SANITARY SEWER EXTENSION FOR

"HINDU TEMPLE ADDITION"

COW PRIV. PROJ. NO. 1129 PPS(607861)

JUNE 2001

SANITARY SEWER EXTENSION
'HINDU TEMPLE ADDITION'
WICHITA, KANSAS
CED PROJ. NO.: 20010742
CERTIFIED ENGINEERING DESIGN, P.A.
810 WEST DOUGLAS, SUITE C
WICHITA, KANSAS 67203
PH.(316)262-8808 FAX.(316)262-1669

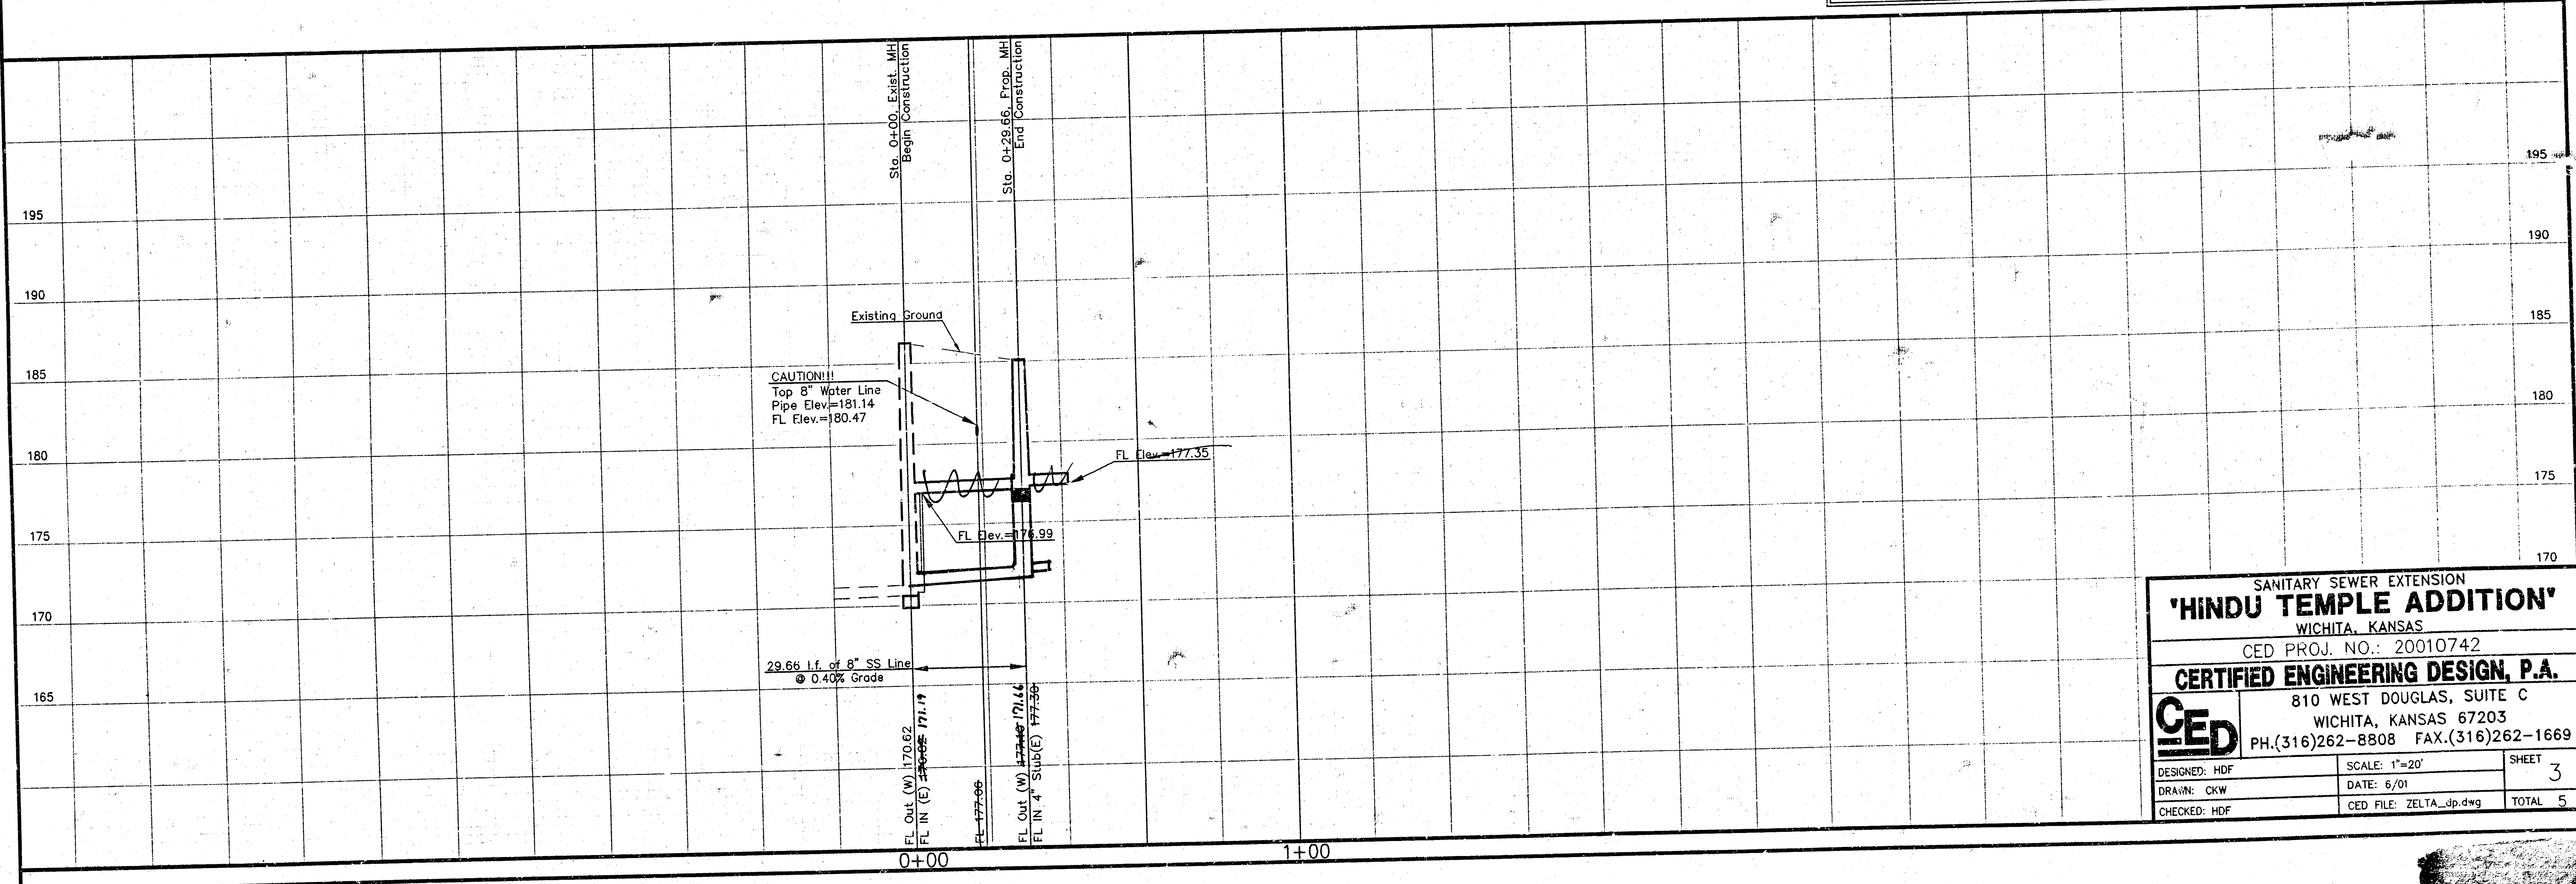
STA. 0+00, Begin Construction
N 4845.68
E 4822.65
Begin Construction
Exist. MH, Top Elev. = 186.26
Construct Outside-Drop-out-MH
Core Existing MH Wall. Install
New 8" Pipe. Seal New 8" Pipe
& Plug to MH Wall w/
Quick-Set Hydraulic Cement.
Concrete Encase 8" Pipe 3"
(Min.) from MH Wall. Fill all MH
Wall Imperfections w/
Quick-Set Hydraulic Cement.
FL IN (E) = ~~170.62~~ 171.14
FL OUT (W) = 170.62

STA. 0+29.66, Prop. SSMH 1
N 4846.37
E 4852.31
Install Type P Std. 4" Dia. MH
Top Elev. = ~~186.26~~ 185.05
FL IN (E) = ~~170.62~~ 171.43
FL OUT (W) = ~~170.62~~ 171.44
Install 10 L.F. of 4" Stub (E)
Stub FL = 177.35
